BEFORE THE UNITED STATES
ENVIRONMENTAL PROTECTION AGENCY

IN THE MATTER OF THE PROPOSED)	COMMENTS OF UNITED PARK
LISTING OF RICHARDSON FLAT)	CITY MINES COMPANY IN
TAILINGS, SUMMIT COUNTY, UTAH,)	OPPOSITION TO PROPOSED
ON THE NATIONAL PRIORITIES LIST)	RULE

FIGURE 1

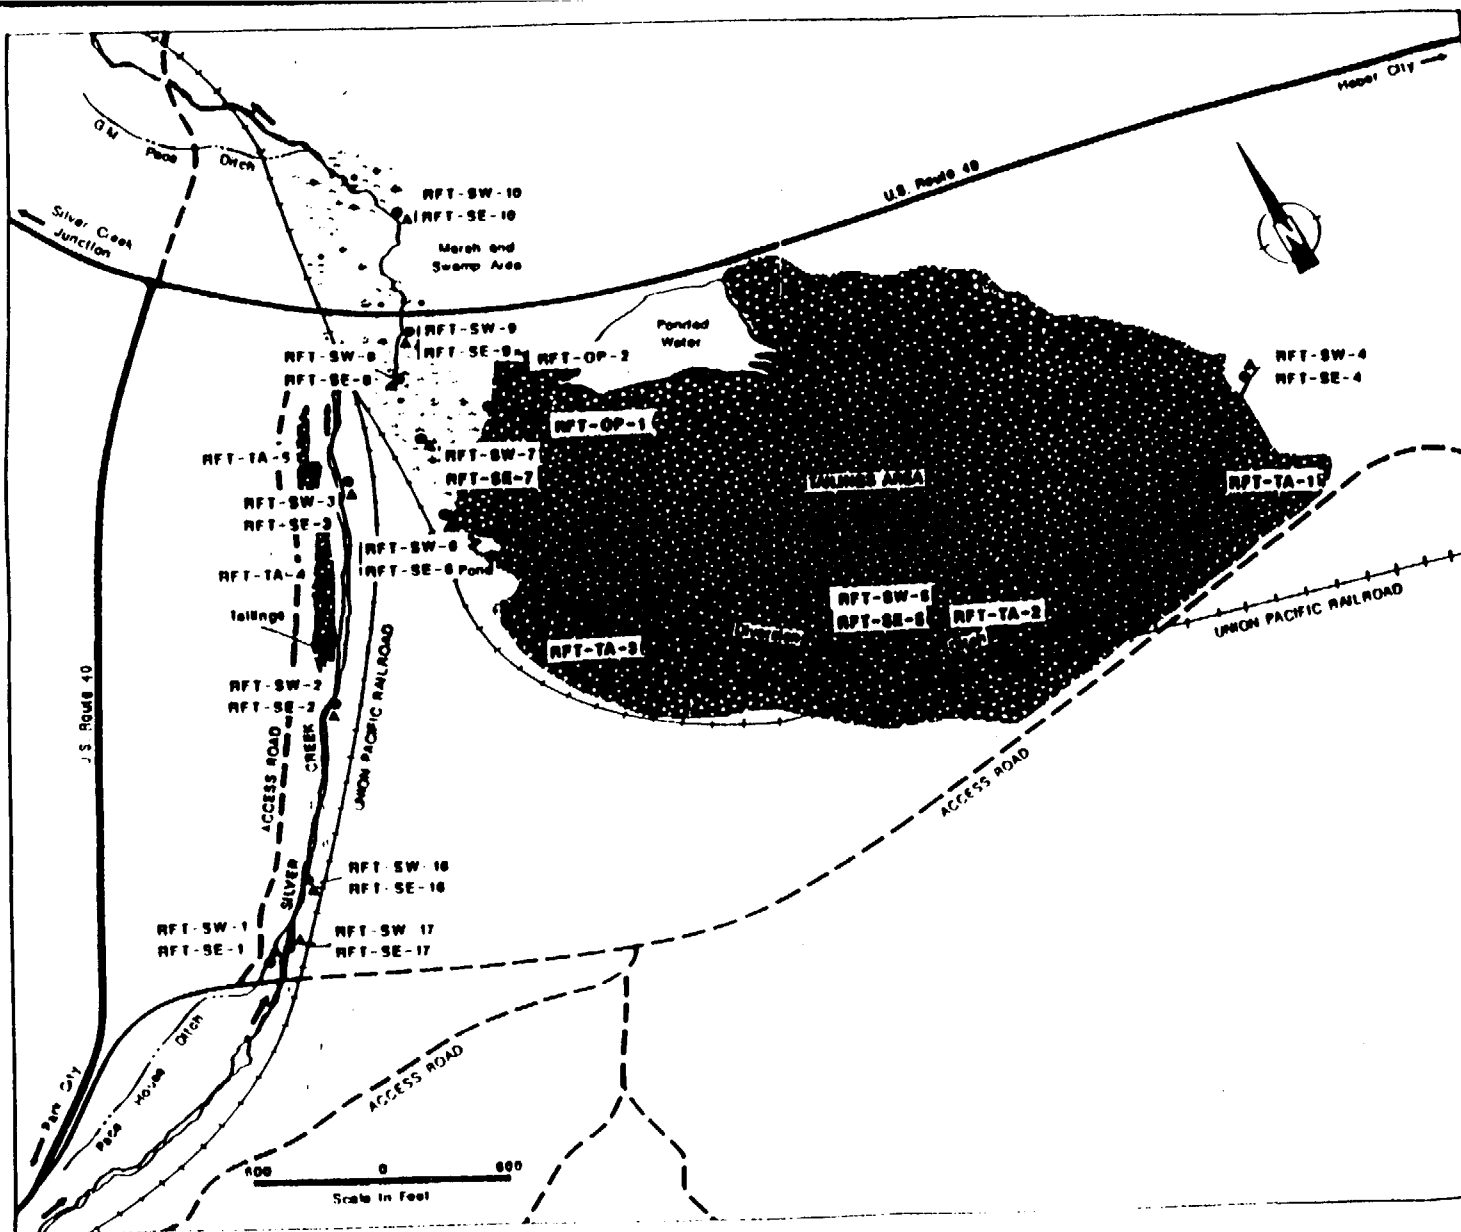
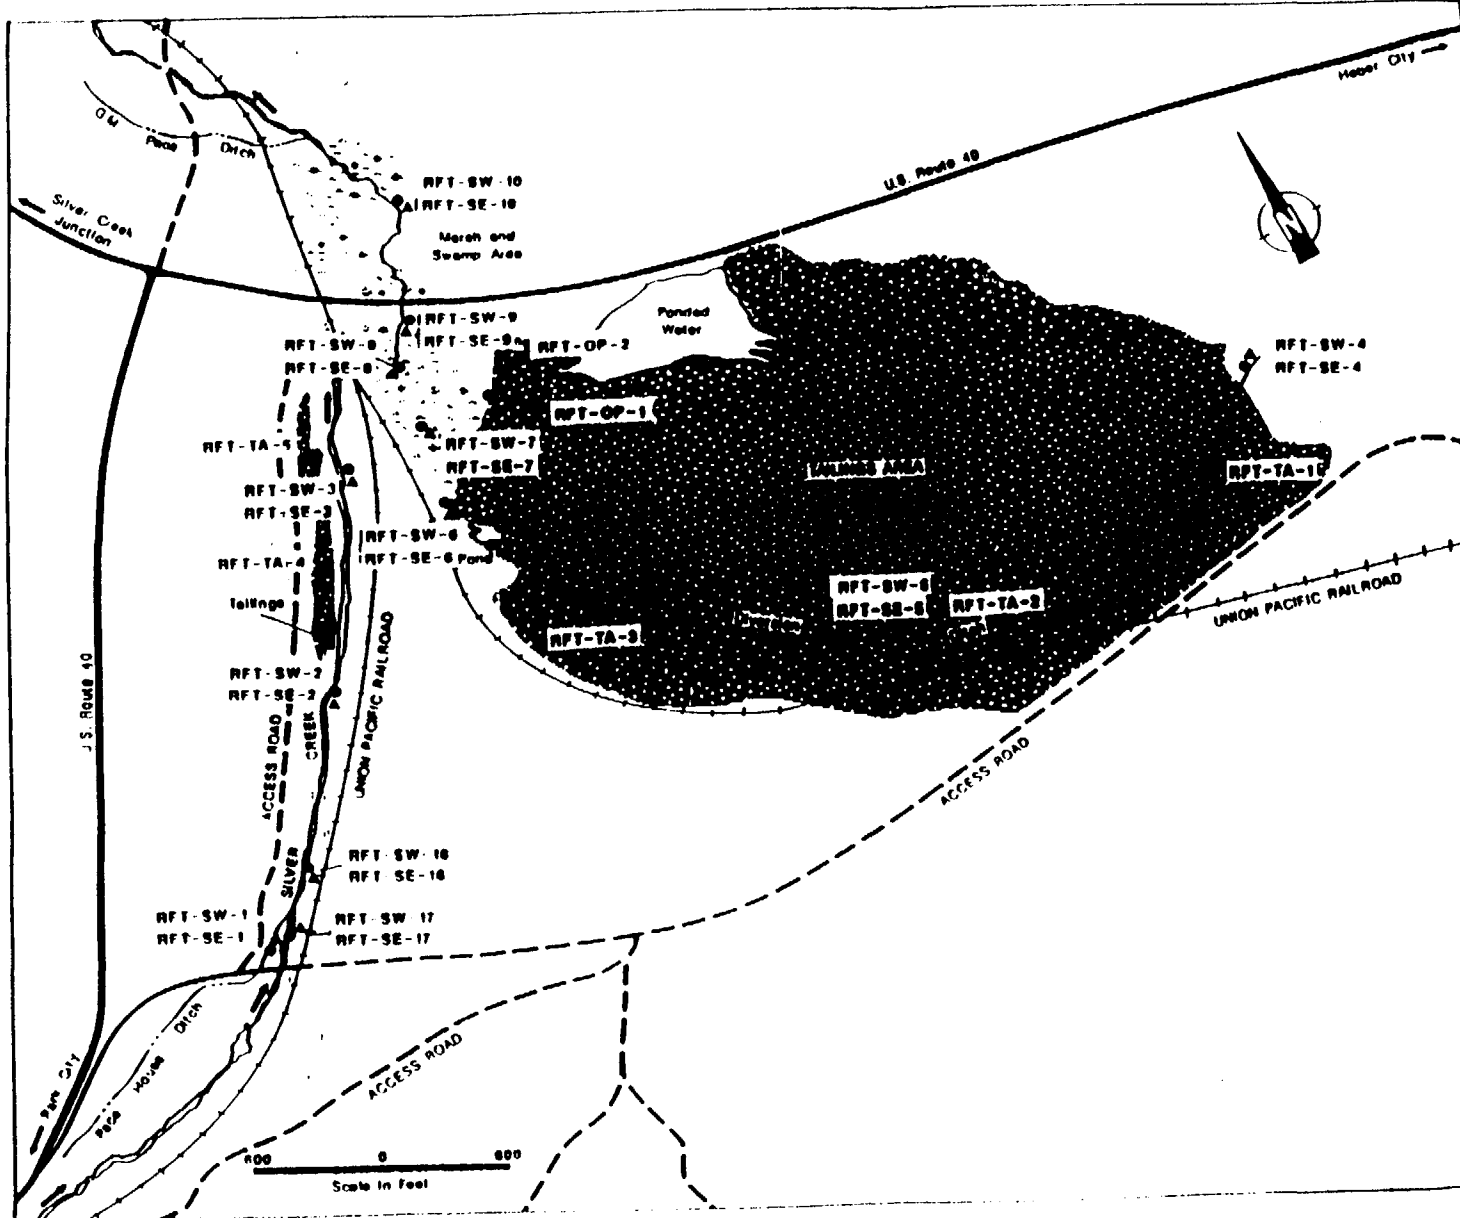
In addition, the unidentified UBSHW employee who allegedly observed the "sloughing of tailings into the Diversion Ditch" took no sample of the "sloughing" material. The Revised Memorandum conveniently states that "tailings were observed sloughing" from the 1989 FIT's RFT-TA-3 sampling site, which sampling site is located (incorrectly) west of and adjacent to United Park's slurry pipe and near the Diversion Ditch on UBSHW's Figure 1 Map attached to the Revised Memorandum.

The distance from RFT-TA-3(Figure 1), where tailings were observed sloughing into the Diversion Ditch and where photograph #2 was taken, to Silver Creek is less than one mile.

However, sampling site RFT-TA-3 of the 1989 Supplemental Site Inspection is not located west of and adjacent to United Park's slurry pipe or near the Diversion Ditch. Sampling site RFT-TA-3 is located over 400 feet to the southeast of the point where it is incorrectly shown on UBSHW's Figure 1 Map and on the Sample Location Map in the 1989 Supplemental Site Inspection Report (EPA's Ref. 4, the second Figure 2).

UNITED PARK CITY MINES COMPANY
CORRECT LOCATION OF SAMPLE RFT-TA-3

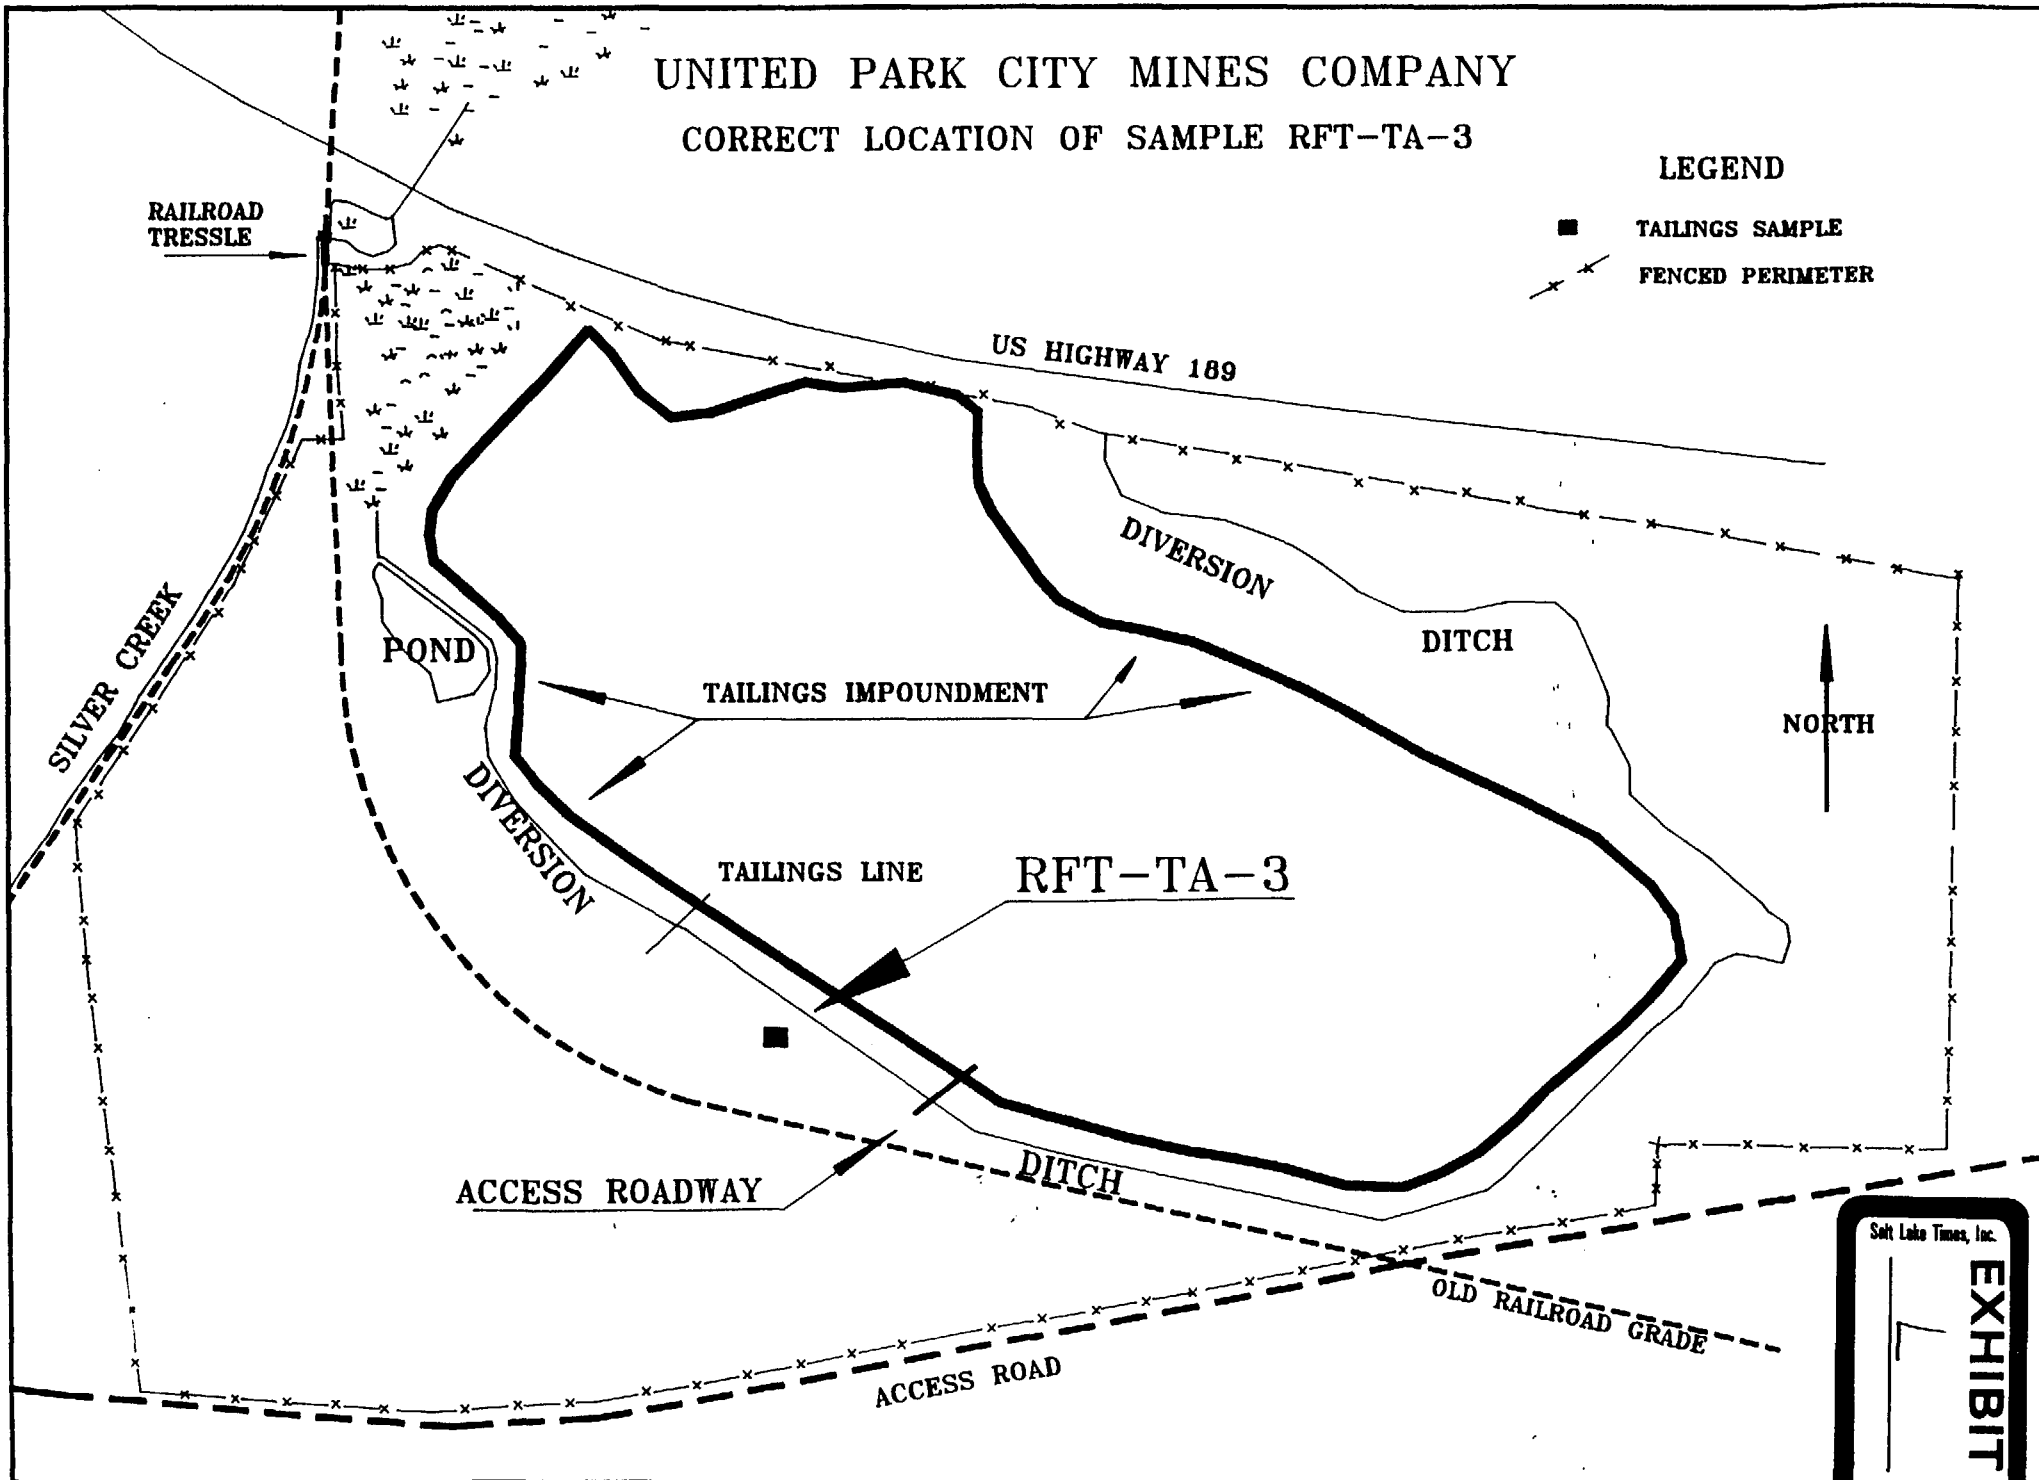
The best evidence of the location of sampling site RFT-TA-3 is EPA's own Photo 4, captioned "South Facing Photo of FIT Member Collecting Tailings Sample RFT-TA-3," in the 1989 Supplemental Site Inspection Report (EPA's Ref. 4, Photo 4). United Park's Map, entitled "Correct Location of Sample RFT-TA-3" and attached hereto as Exhibit L, accurately reflects the location of sample RFT-TA-3 and of EPA's Photo 4.

As revealed in EPA's Photo 4, the actual site of sample RFT-TA-3 is in a different location from that identified on the UBSHW and 1989 FIT maps and in UBSHW Photo 2 (a photograph showing the slurry line). EPA's Photo 4 shows sample RFT-TA-3 being taken in a depression with a mound of naturally occurring alluvial material clearly depicted in the right of the photograph. This mound of alluvial material separates the actual sampling location of RFT-TA-3 from the purported sampling site referenced in UBSHW's Figure 1 Map, UBSHW's Photo 2, and the 1989 FIT's Sample Location Map. Therefore, the material which is located at the purported sampling location cannot be characterized as the same material as that in the area where sample RFT-TA-3 was actually taken.
